Access Compliance Report Public Rights-of-Way (Curb Ramps)

Main Street: WASS_ST Cross Street: CHARLOMA_DR Location: NE

ADA ID: RPAT211011101912 Ramp Type: Type 1 - Perpendicular Diagonal Initial Pass/Fail: Fail Overall Compliance: No Severity Score: 2

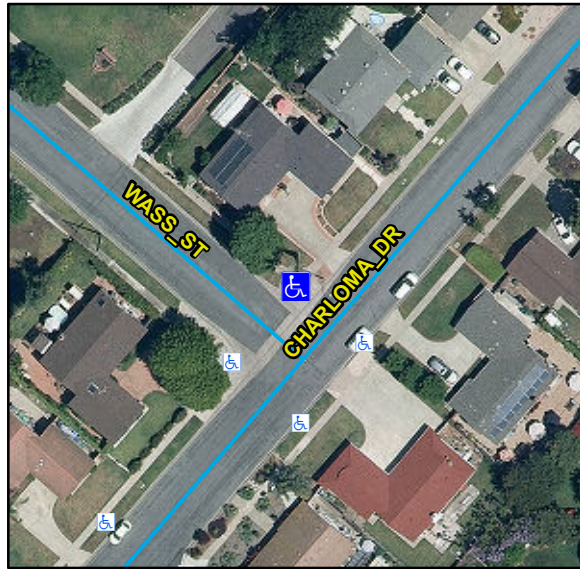
Compliance	Description	Data	Compliance	Description	Data
N/A	Ramp Length (in)	121	N/A	Flare Type LT	
Yes	Ramp Width (in)	55			N/A
Yes	Ramp Run Slope (%)	8	N/A	Flare Slope LT (%)	N/A
No	Ramp Cross Slope (%)	4.6	N/A	Flare Traversable LT	N/A
N/A	Landing Present	N/A	N/A	Flare Type RT	
N/A	Landing Length (in)	N/A			N/A
N/A	Landing Width (in)	N/A	N/A	Flare Slope RT (%)	N/A
N/A	Landing Run Slope (%)	N/A	N/A	Flare Traversable RT	N/A
N/A	Landing Cross Slope (%)	N/A	N/A	DWS Provided	N/A
N/A	Landing Movement Obstructed?	N/A	N/A	DWS Contrast	N/A
	Landing Movement Type	N/A	N/A	DWS Length (in)	N/A
N/A	Landing Shared	N/A	N/A	DWS Full Width	N/A
N/A	Clear Space	Yes	N/A	DWS Offset Left (in)	N/A
N/A	Clear Space To Crosswalk (in)	N/A	N/A	DWS Offset Right (in)	N/A
N/A	Marked Crosswalk 1	No	N/A	Marked Crosswalk 2	No
	Crossing 1 Direction	W		Crossing 2 Direction	S
	Marked Crosswalk 1 Width (in)	N/A		Marked Crosswalk 2 Width (in)	N/A

N/A	Ramp Inside Crosswalk 1	N/A	Yes	Ramp Inside Crosswalk 2	N/A
	Crossing 1 Slope (%)	2.8		Crossing 2 Slope (%)	6.4
	Crossing 1 Cross Slope (%)	4.5		Crossing 2 Cross Slope (%)	2.9
N/A	Gutter Ponding	N/A	No	Curb Slope	8.6
Yes	Gutter Lip Height (in)	0		Road Run Slope (%)	1.1
N/A	Gutter Run Slope (%)	N/A		Road Cross Slope (%)	4.5
N/A	Gutter Cross Slope (%)	N/A			
Yes	Overall Surface Condition: Acceptable		Yes	Perp Joint Present	Yes
	Cross Gutter Present?	Yes		Spandrel Present?	Yes
	Replace Cross Gutter?	No		Replace Spandrel?	No

Remove & Replace Curb Ramp With Two New Directional Ramps or Equivalent.
